Ernest J. Harkness
Vice President440-280-5382
Fax: 440-280-8029June 23, 2014
L-14-150

Perry Nuclear Power Plant
Docket No. 50-440, License No. NPF-58
Request for Licensing Action to Amend Technical Specification 3.4.11, "RCS Pressure and Temperature (P/T) Limits"

Subject: Request for Licensing Action to Amend Technical Specification 3.4.11, "RCS Pressure and Temperature (P/T) Limits."

Figure 3.4.11-1(a): Pressure Test Curve (Curve A) (Valid Up to 22 EFY - Unit 1)

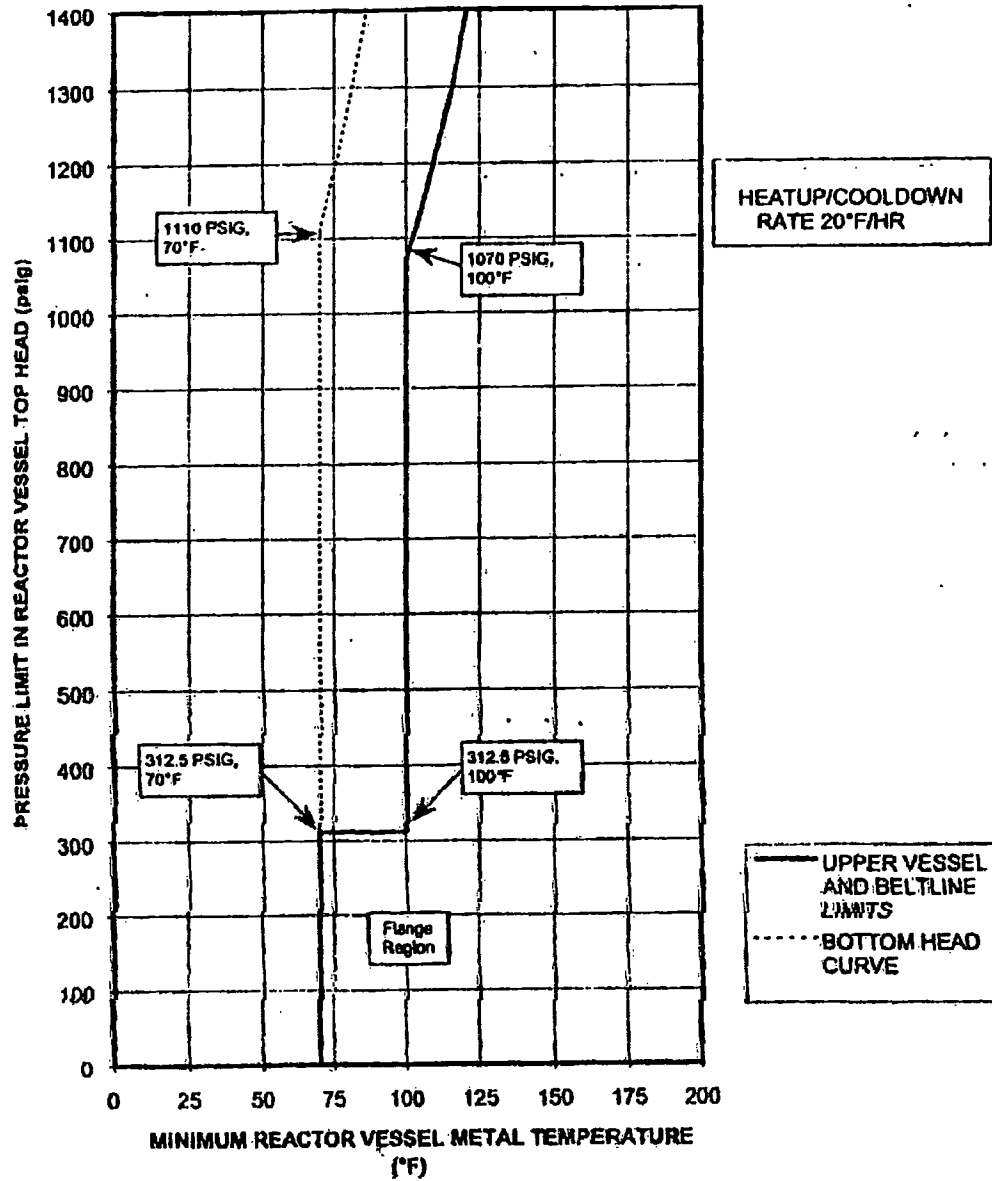
Figure 3.4.11-1(a): Pressure Test Curve (Curve A) (Valid up to 22 EFPY - Unit 1)

This 22 EFPY figure will be deleted.

REMOVE this [22 EFY] FIGURE.

Figure 3.4.11-1(b): Non-Nuclear Heatup/Cooldown (Curve B) (Valid Up to 22 EFPY - Unit 1)

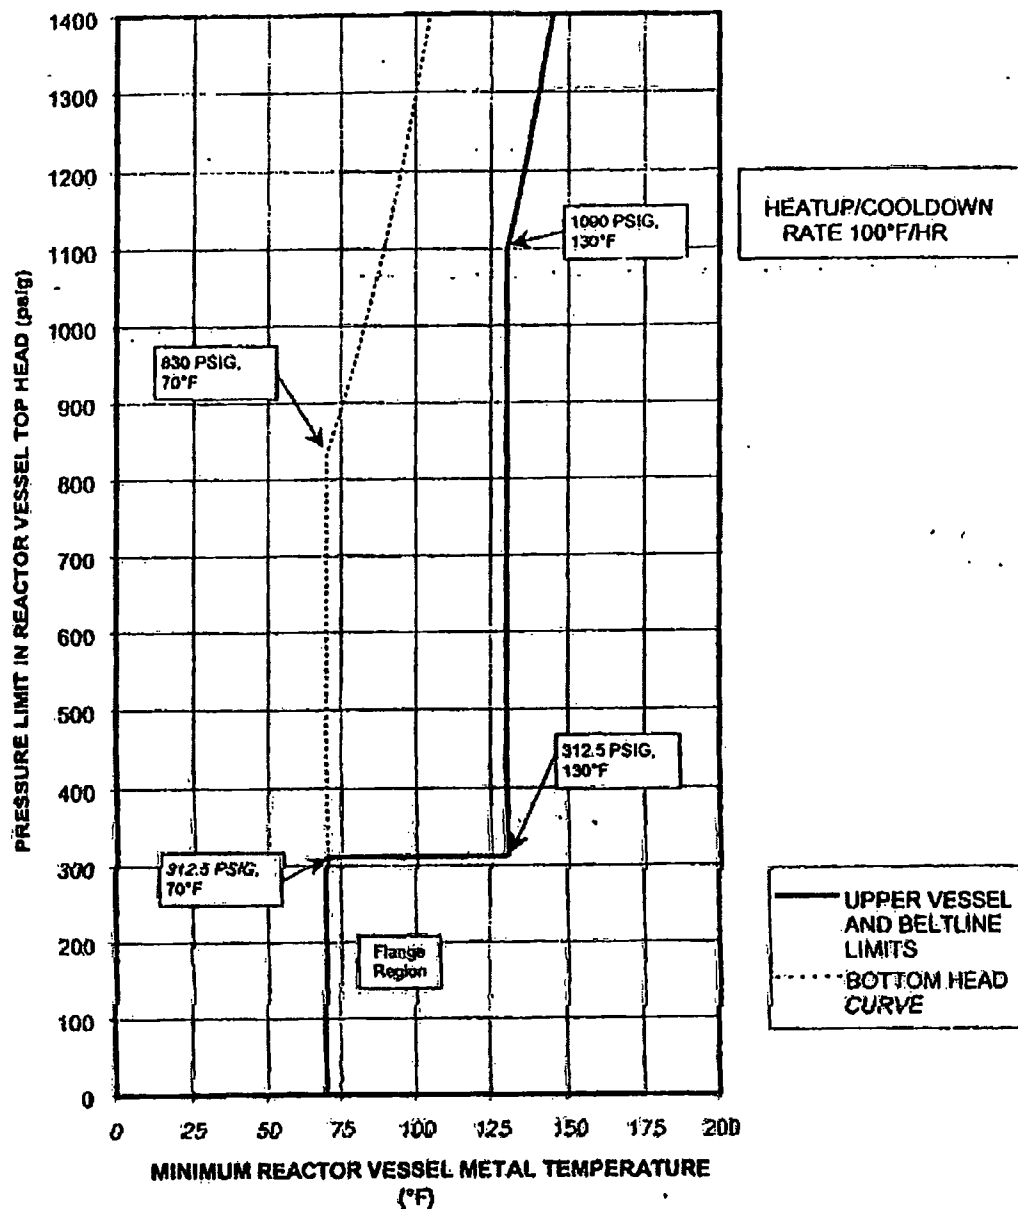
Figure 3.4.11-1(b): Non-Nuclear Heatup/Cooldown (Curve B) (Valid up to 22 EFPY - Unit 1)

This 22 EFPY figure will be deleted.

REMOVE this [22 EFPY] FIGURE.

Figure 3.4.11-1(c): Core Critical Operation (Curve C) (Valid Up to 22 EFPY - Unit 1)

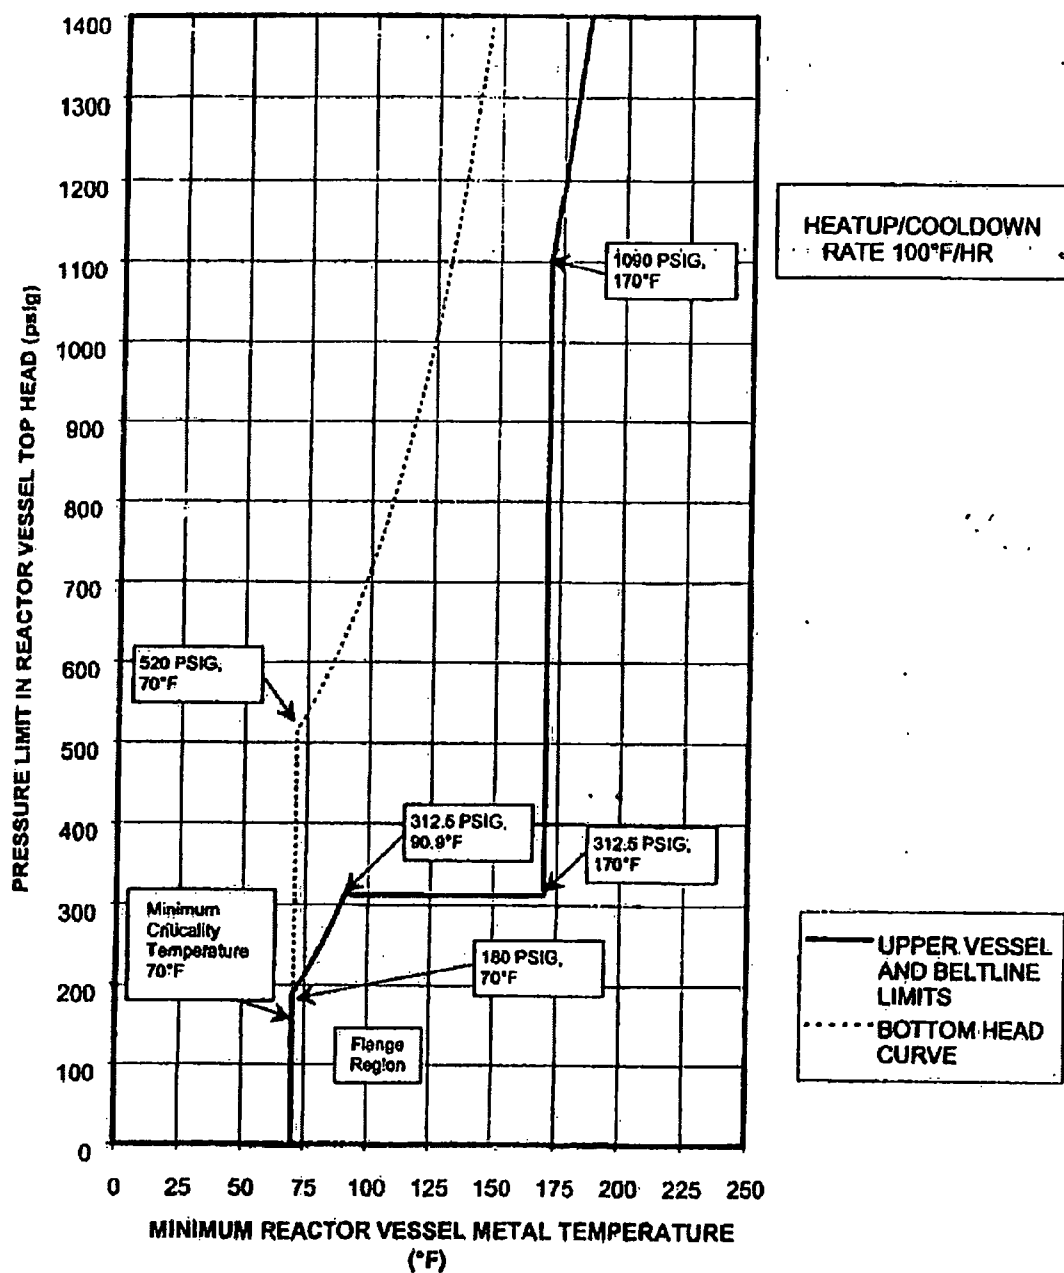
Figure 3.4.11-1(c): Core Critical Operation (Curve C) (Valid up to 22 EFPY – Unit 1)

This 22 EFPY figure will be deleted.

REMOVE this [22 EFPY] FIGURE.

Figure 3.4.11-1(d): Pressure Test Curve (Curve A) (Valid Up to 32 EFPY – Unit 1)

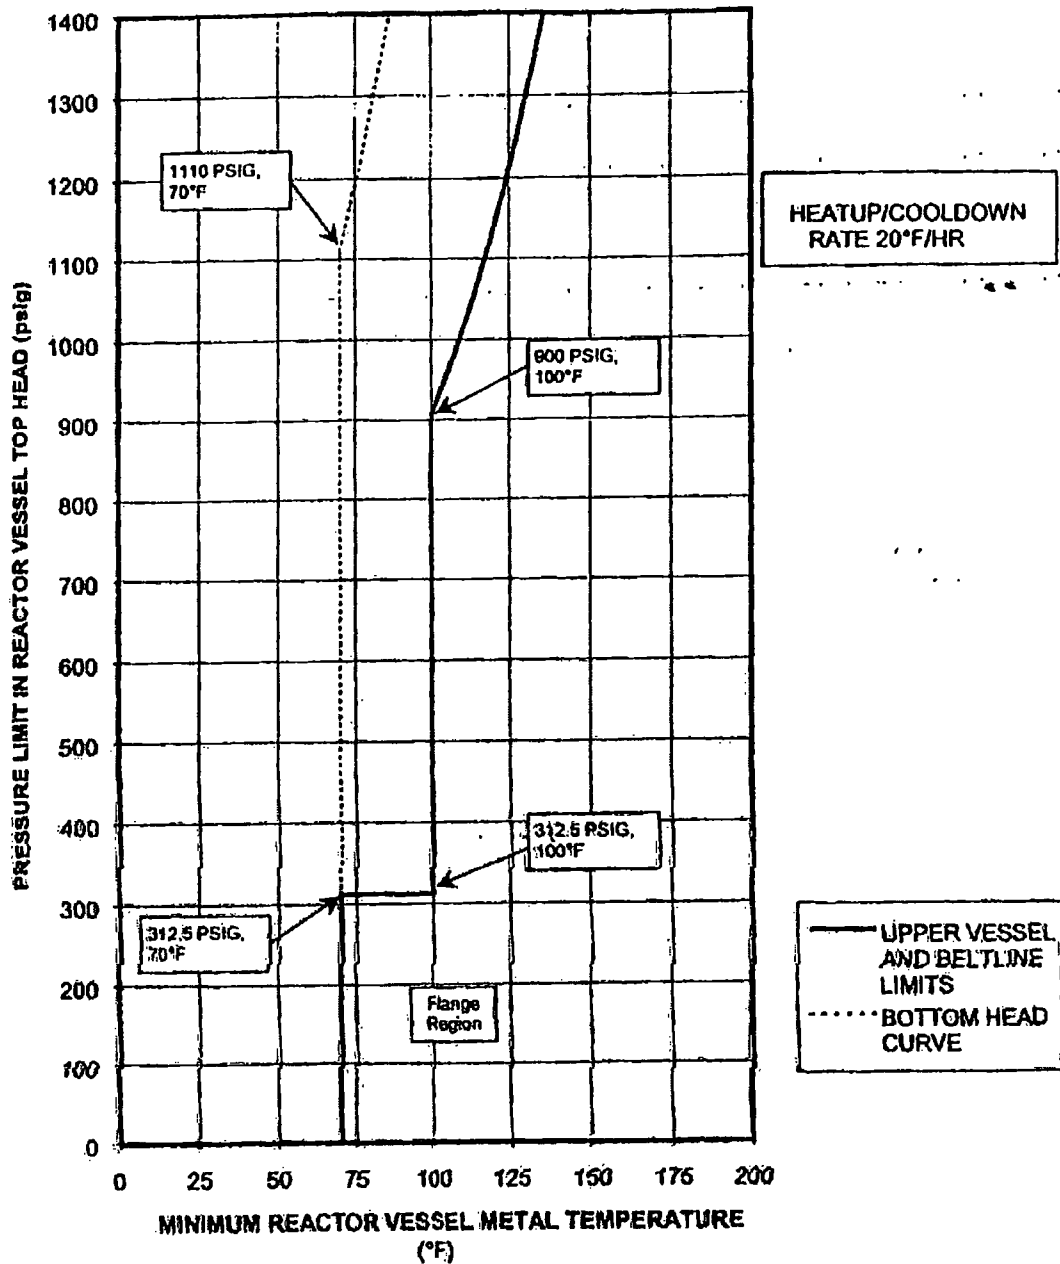
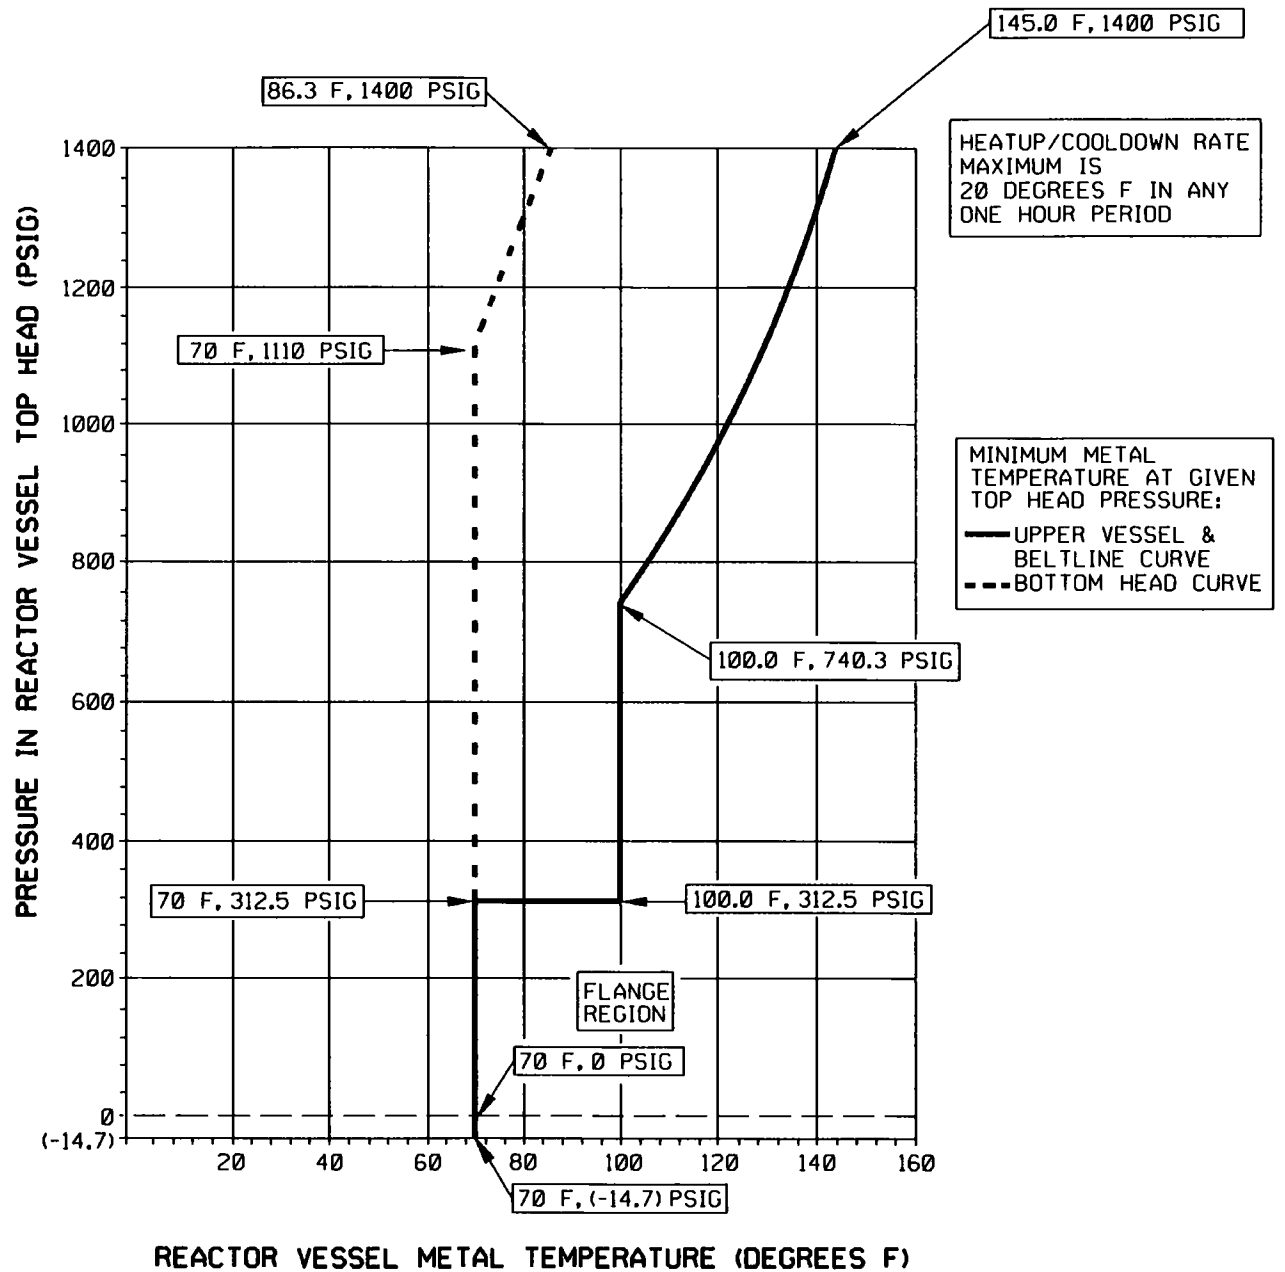
Figure 3.4.11-1(d): Pressure Test Curve (Curve A) (Valid up to 32 EFPY – Unit 1)

This figure will be updated and retitled as Figure 3.4.11-1(a): Pressure Test Curves (Valid up to 32 EFPY). The words "Curve A" and "Unit 1" were dropped from the title; Curve A was a carryover from when one P/T limit figure had multiple curves, and Unit 1 is unnecessary as PNPP is a single unit site. The word "Curve" was pluralized as the figure depicts two curves. The word "Limit" was dropped from the Y axis label; this axis depicts pressure in the reactor vessel top head and the curves depict the actual pressure limits. The word "Minimum" was dropped from the X axis label; this axis depicts reactor vessel metal temperature and the curves depict the actual minimum required temperatures. The word "Maximum" was added to the figure's note box describing heatup/cooldown rate; this note intended the heatup/cooldown rate to be an "up to a maximum" rate rather than a single specific rate as currently depicted. The clarification words "Minimum metal temperature at given top head pressure" were added to the curve legend box as a result of the editorial changes made to the X and Y axis labels.

With the update described in the technical evaluation below, portions of the upper vessel and beltline P/T limit curve will generally shift downward and to the right, and will extend into the vacuum region with a new endpoint (70 F, -14.7 psig). Both P/T limit curves will now include temperature limits at their existing upper (1400 psig) endpoints.

REMOVE and REPLACE this FIGURE with
the RENAMED and UPDATED FIGURE.

FIGURE 3.4.11-1(a): PRESSURE TEST CURVES (VALID UP TO 32 EFY)

Figure 3.4.11-1(e): Non-Nuclear Heatup/Cooldown (Curve B) (Valid Up to 32 EFY - Unit 1)

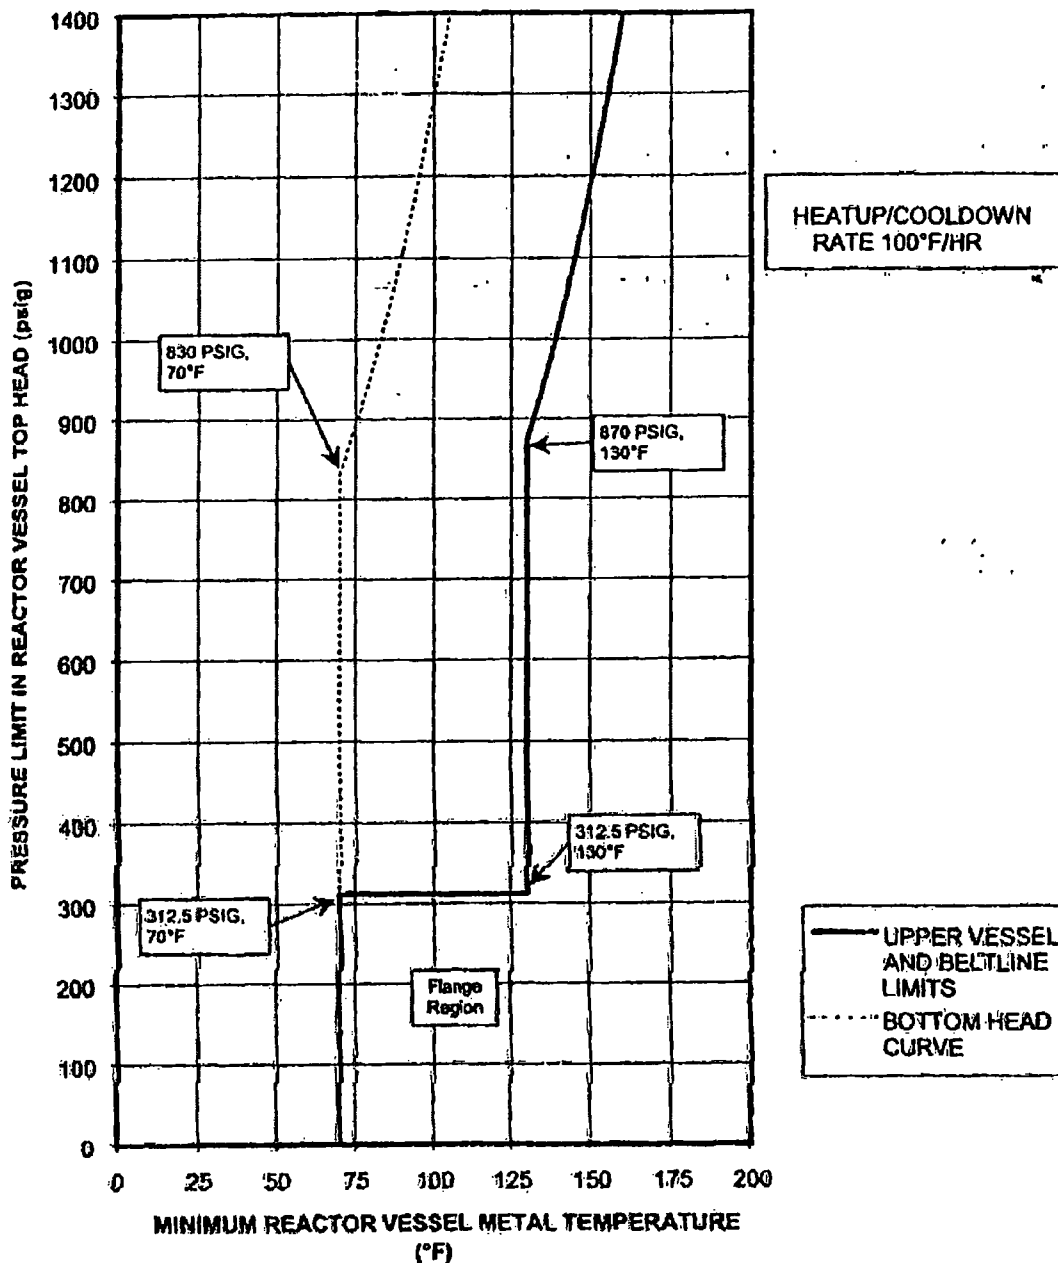
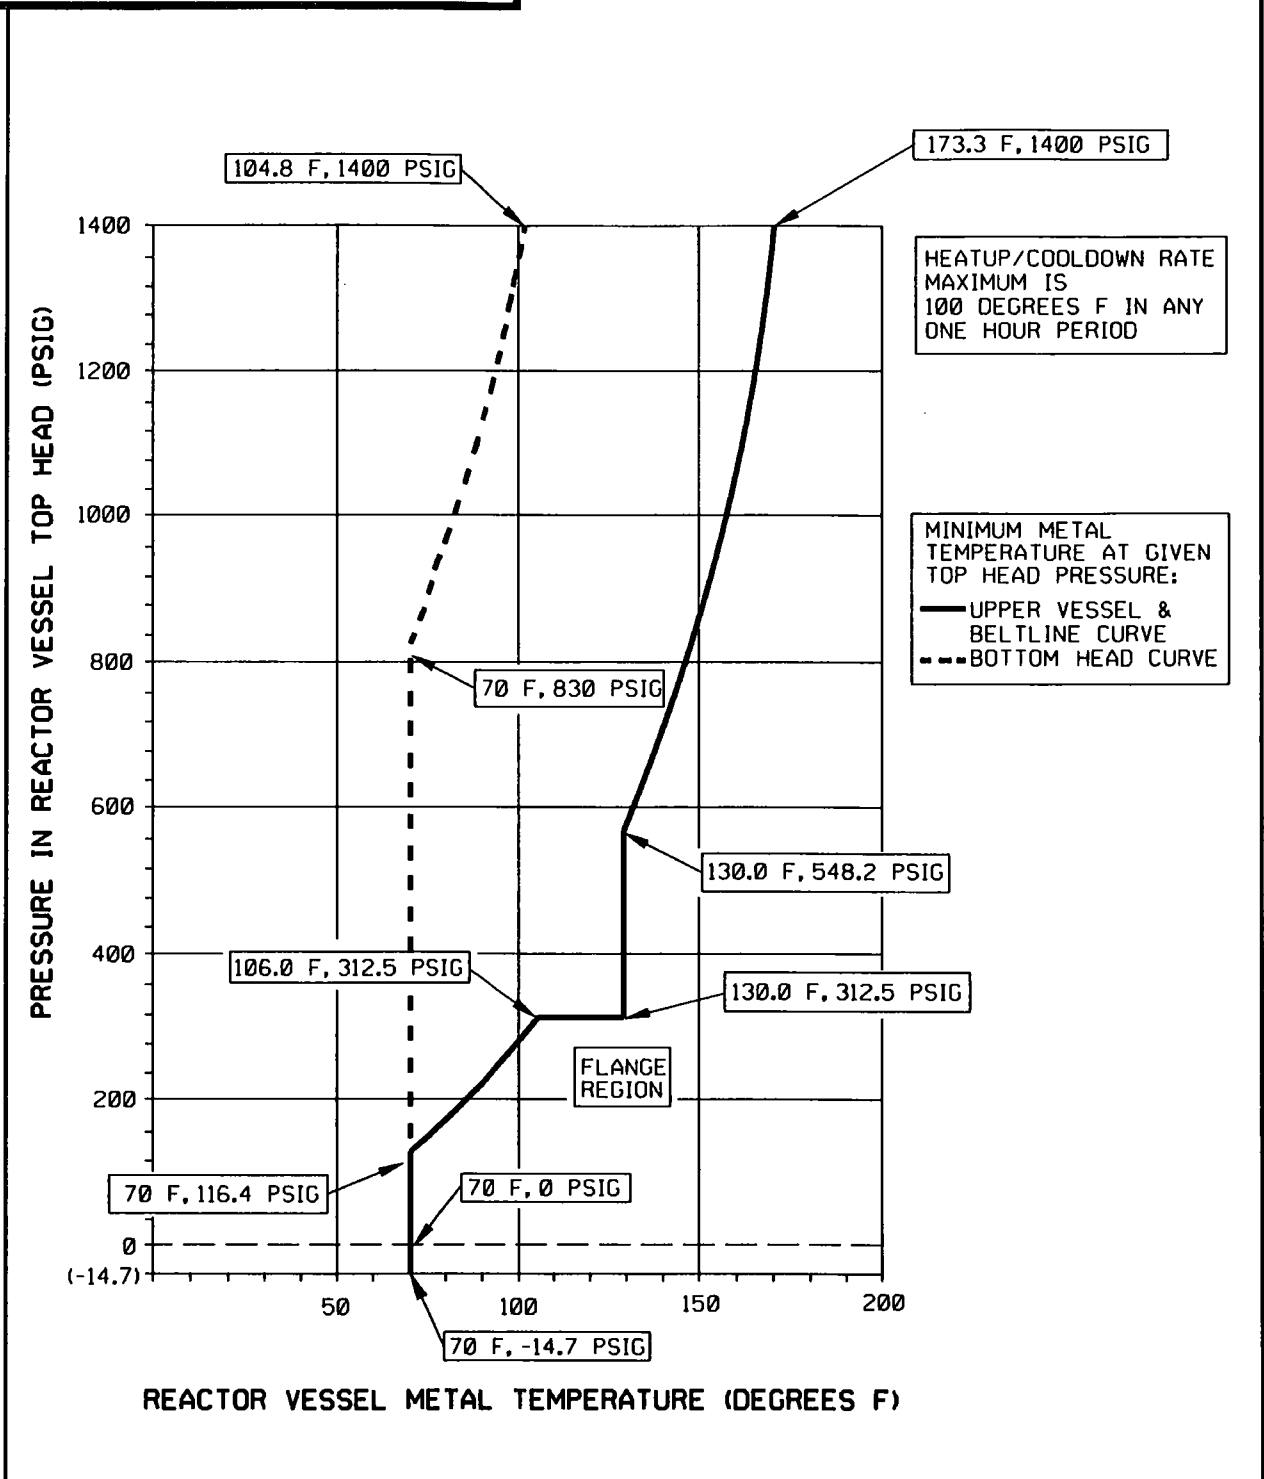
Figure 3.4.11-1(e): Non-Nuclear Heatup/Cooldown (Curve B) (Valid up to 32 EFPY - Unit 1)

This figure will be updated and retitled as Figure 3.4.11-1(b): Non-Nuclear Heatup/Cooldown Curves (Valid up to 32 EFPY). The words "Curve B" and "Unit 1" were dropped from the title; Curve B was a carryover from when one P/T limit figure had multiple curves, and Unit 1 is unnecessary as PNPP is a single unit site. The word "Curves" was added to the title as the figure depicts two curves. The word "Limit" was dropped from the Y axis label; this axis depicts pressure in the reactor vessel top head and the curves depict the actual pressure limits. The word "Minimum" was dropped from the X axis label; this axis depicts reactor vessel metal temperature and the curves depict the actual minimum required temperatures. The word "Maximum" was added to the figure's note box

describing heatup/cooldown rate; this note intended the heatup/cooldown rate to be an “up to a maximum” rate rather than a single specific rate as currently depicted. The clarification words “Minimum metal temperature at given top head pressure” were added to the curve legend box as a result of the editorial changes made to the X and Y axis labels.

With the update described in the technical evaluation below, portions of the upper vessel and beltline P/T limit curve will generally shift downward and to the right, and will extend into the vacuum region with a new endpoint (70 F, -14.7 psig). Both P/T limit curves will now include temperature limits at their existing upper (1400 psig) endpoints.

REMOVE and REPLACE this FIGURE with
the RENAMED and UPDATED FIGURE.

FIGURE 3.4.11-1(b): NON-NUCLEAR HEATUP/COOLDOWN CURVES (VALID UP TO 32 EFY)
